**Tree Inventory, Assessment,
and
Protection Report**

**16195 George Avenue, Los Gatos
Los Gatos, CA 95032**

Town of Los Gatos

August 9, 2021

Appendix A: Tree Inventory Map and Site Plan

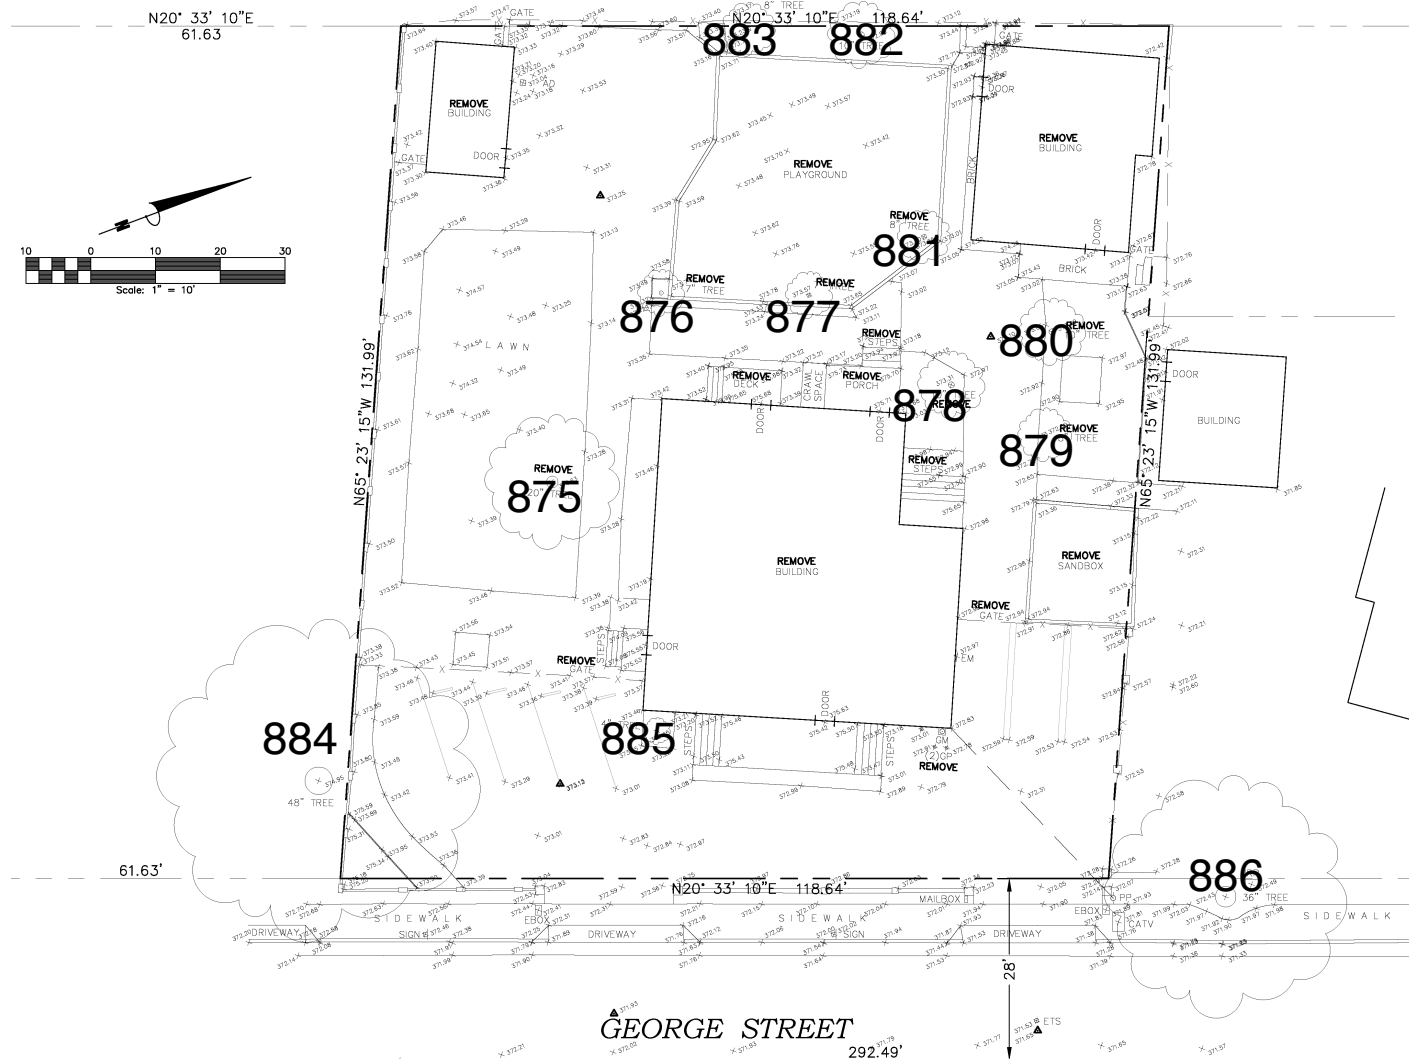
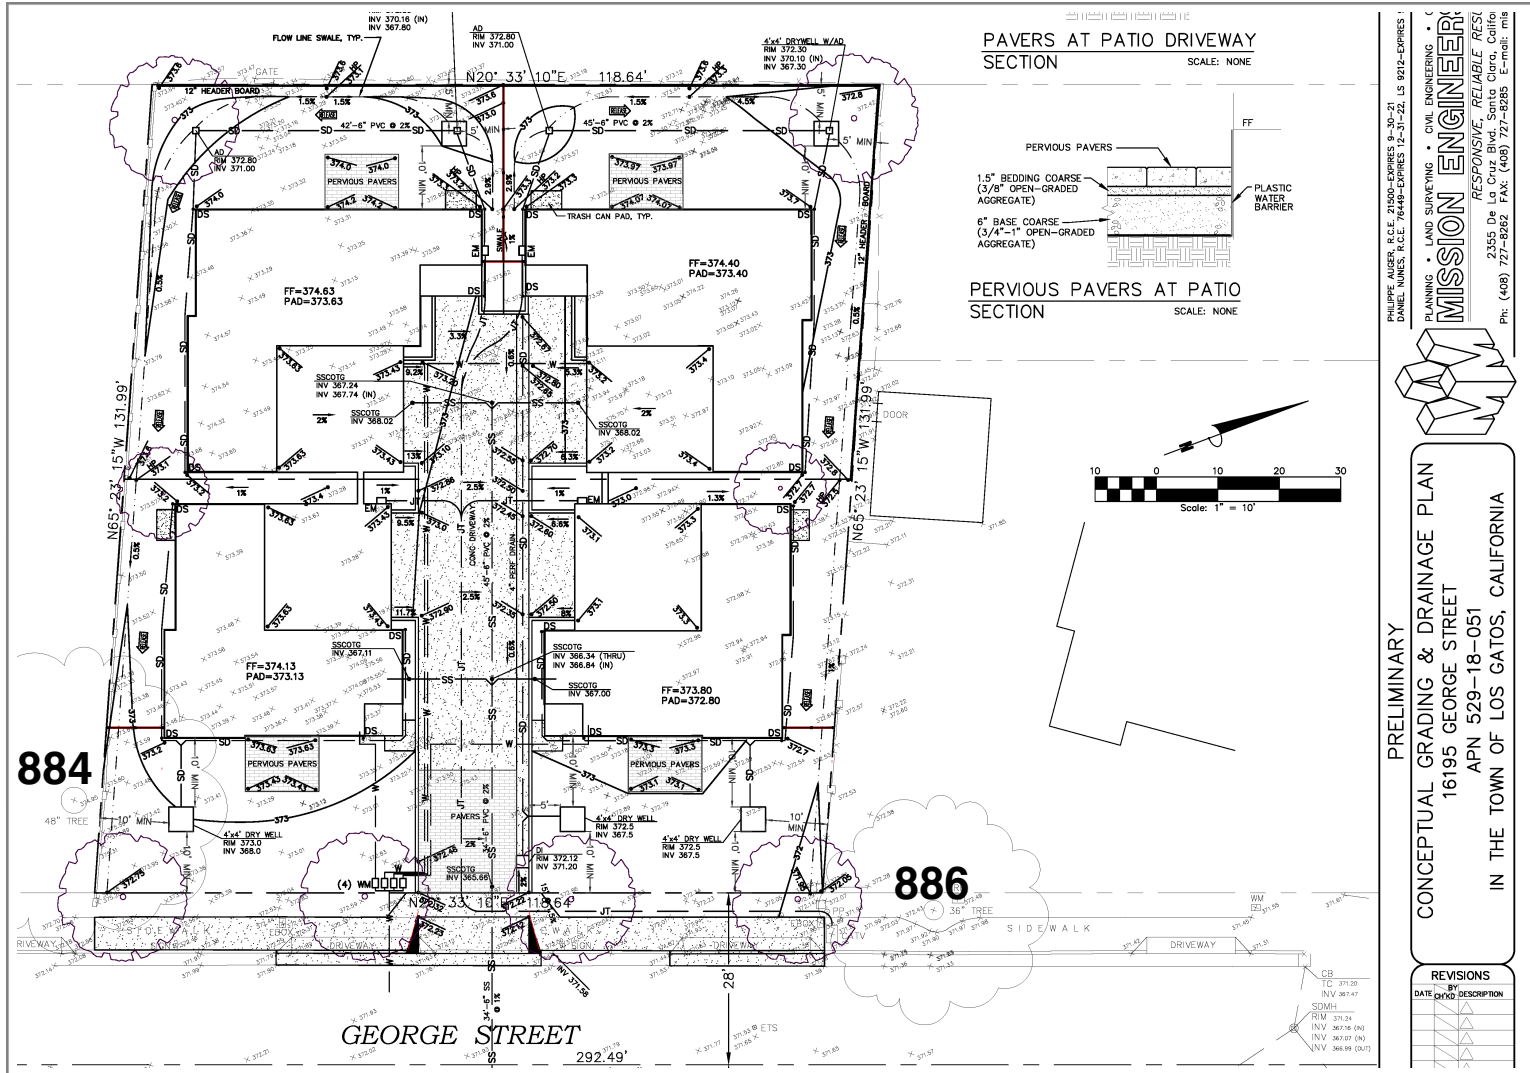
Ten trees on the site are expected to be highly impacted and removed. Two trees, coast redwoods #884 and #886, originate on the adjacent site. The storm drain and connection near coast redwood #884 should be moved closer to the interior or plans revised to avoid the tree. The impact is moderate to high in this location around this particular tree. No other impacts are expected.

1. Place tree numbers on all the plans. Make sure the trees are clearly indicated for removal on all the plans. The trees should also be very clearly marked on site prior to removal.

2. Place tree protection fence around #884 at a radius of 30 feet. Move the storm drain adjacent to the tree closer to the center of the property and avoid grading within 30 feet of the outer trunk. Install temporary irrigation or soaker hoses in all tree protection zones and provide supplemental watering during construction within all TPZ areas. Monitor watering times or amounts to ensure adequate soil saturation. (A 5/8" soaker hose requires about 200 minutes to deliver one inch of water to a garden. This number is affected by the length of the hose and the overall rate of flow from the faucet. A good rule of thumb is to expect about ½ GPM as a standard faucet flow rate.). Infrequent deeper watering is preferred.

6. Place all the tree protection fence locations and guidelines on the plans including the grading, drainage, and utility plans. Alternatively create a separate plan sheet that includes all three protection measures labeled "T-1 Tree Protection Plan."

FIGURE 1: BRIDGING FOR ROOT PROTECTION

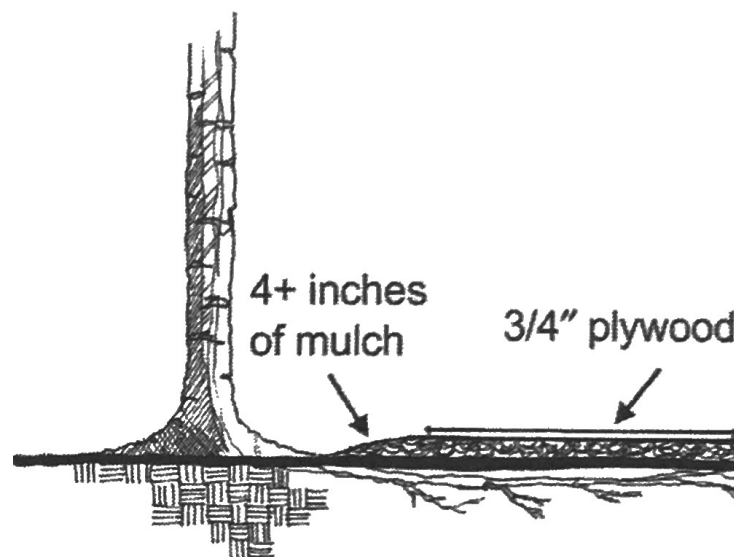
Regarding recommendations for bridging for tree and soil protection. Below are the specifications for performing this type of protection scheme when fence is not practical or encroachment is within the typical TPZ radius. The neighbor fence will protect the trunk.

Tree protection will be focussed around the adjacent coast redwood #884. The protection fence will need to be placed at the property boundary at a radius of 30 feet where possible around this tree. If not possible construction monitoring and bridging will be required for activity under the tree. For bridging place at least four inches of mulch, bark, or wood chips in the TPZ encroachment area or use 4 x4 timbers (dimensional lumber) on the soil surface. Place three quarter inch plywood or steel road plate on the lumber or mulch to create a soil compaction barrier within the Tree Protection Zone.
